Preliminary Consultation
HISTORIC PRESERVATION COMMISSION STAFF REPORT

Address:	7714 Takoma Ave., Takoma Park	Meeting Date:	3/28/18
Resource:	Contributing Resource Takoma Park Historic District	Report Date:	3/21/18
Review:	Preliminary Consultation	Public Notice:	3/14/18
Applicant:	Marianna Diggs	Staff:	Dan Bruechert
Proposal:	Building Addition

The applicant proposes to construct a one-story, one room addition off of the southwest of the historic house, accessed by a newly created hallway, and construct a deck in front of the proposed addition. The applicant additionally proposes to replace the non-historic bottom sash of all of the historic windows. The applicant proposes to expand the small one-story addition in the rear of the house by adding a second story in matching cladding. Lastly, the applicant proposes removing the non-historic ADA ramp and non-historic rear stairs.

Figure 1: Right side of the house showing the location of the proposed hallway.

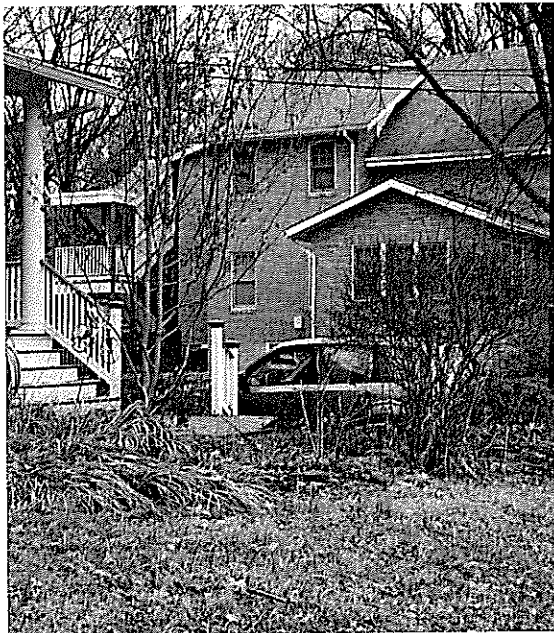
The applicant is proposing to construct a rear gable addition off of the left rear corner of the house that will be accessed by a newly created hallway. The addition will be approximately 17' × 21' (seventeen feet by twenty-one feet) and will have a brick foundation and be clad using Hardi siding with a 10" (ten inch) reveal with a steeply-pitched metal roof. The addition in the rear will project 4'2" (four feet, two inches) beyond the wall plane of the historic side gable-L at the front of the house. The creation of the new hallway will require the removal of the historic exterior wall behind the side gable-L addition (see Fig. 1 below).

Staff is less concerned about the removal of the portion of the wall behind the front side gable-L. While the loss of this historic fabric is not a desirable outcome, the visibility of this element is limited to the view shown in Fig. 1 and its loss will not have a major impact on the surrounding District.

3 Site Plan- New Design
SCALE: 1" = 20'

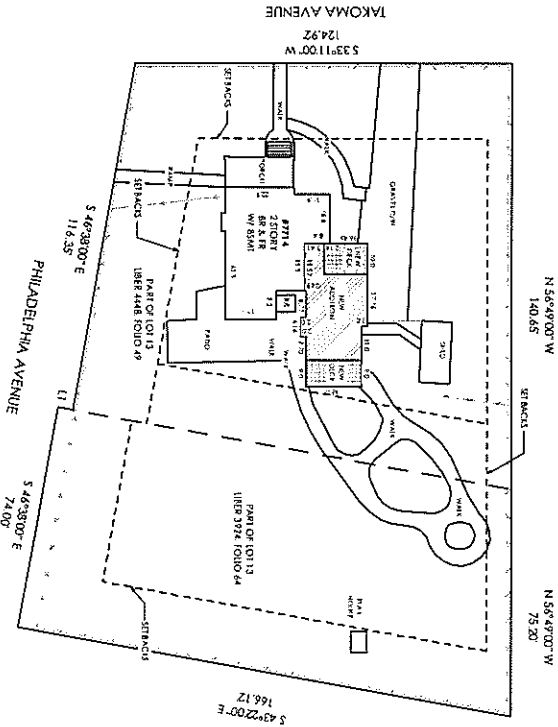
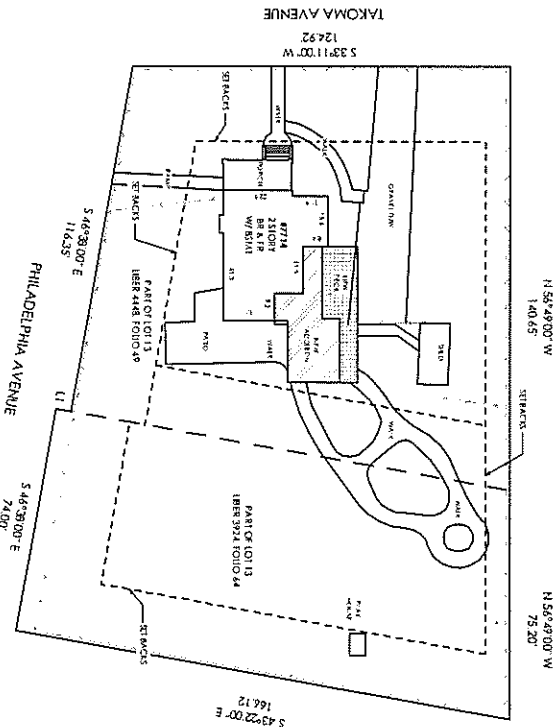
Staff finds that the applicant made several revisions based on the recommendations by the HPC at the February 13th meeting. The location of the addition has been moved further toward the rear, and it projects much less than the previous submission (see attached) that projected more than 14' (fourteen feet) from the side gable-L. The roof form has been simplified, so that the new hallway is covered in a shed roof, with a single rear-facing gable roof over the addition, instead of the more complex side and rear gable proposal previously submitted. One substantial change from the previous submission has to do with the height of the roof on the addition. The proposed roof is much taller than the previous submission. The ridgeline extends to the eave of the rear gable on the historic house (at the level of the attic floor). This is 6' - 8' (six feet to eight feet) taller than the side gable-L roof at the front of house and will be largely visible from the public right-of-way.

The HPC voiced support for moving any building additions to the rear of the house, determining that the side and rear elevations (visible from Philadelphia Ave.) are secondary elevations and can accommodate more change without damaging the historic character of the building. The applicant has relocated the proposed construction, however, it still projects beyond the wall plan.
